Responses to Heritage Victoria permit conditions

Her Majesty's Theatre

17 Lydiard Street South, Ballarat 3350 VIC

Date: 20/12/2022

Figure 1
Storage area during construction. Storage associated with front row  and storage associated with fire protection.

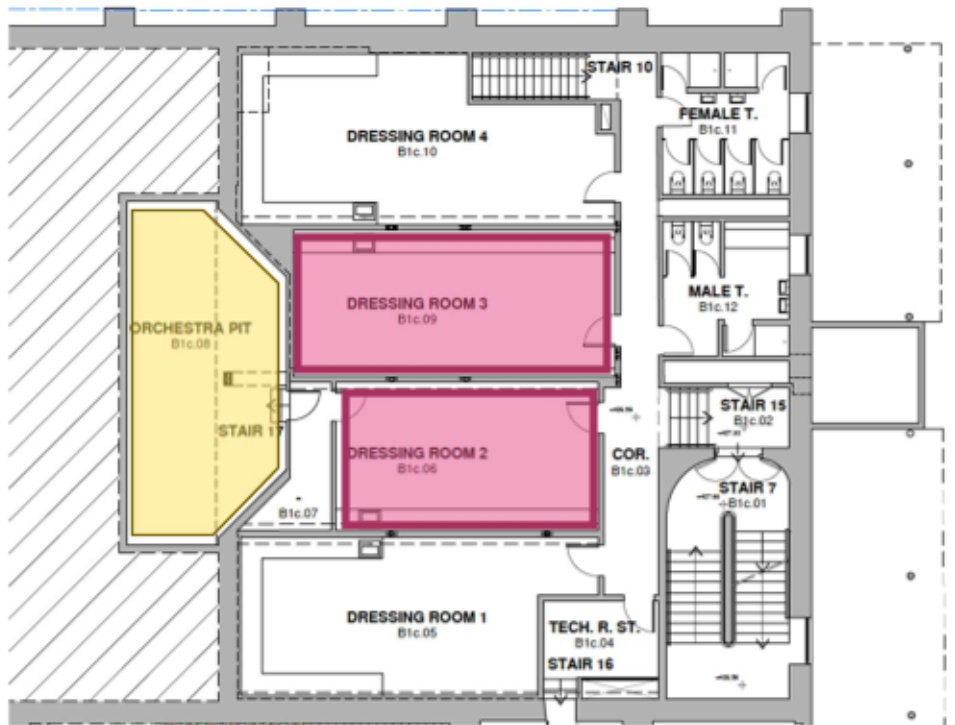
Until the structural remediation works are completed on the balustrades, the 68 chairs from the first rows of the balconies will be stored in the orchestra pit part of the auditorium.

During the construction, all chairs will be stored in the Back of House – Level B1 – Dressing rooms 2 and 3 (B1c-06 and 09) recently refurbished during the stage 2.

Figure 8
Angle of the photography.

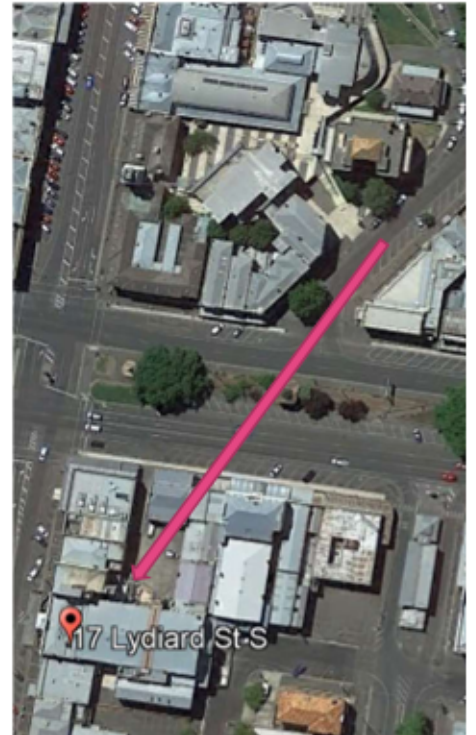
Figure 7
Photograph from Camp Street. The top of the north stair is visible including the eastern elevation with some limitation due to the angle.

Figure 9
Detail of the photograph above with north fire stair on the background (eastern façade in pink).
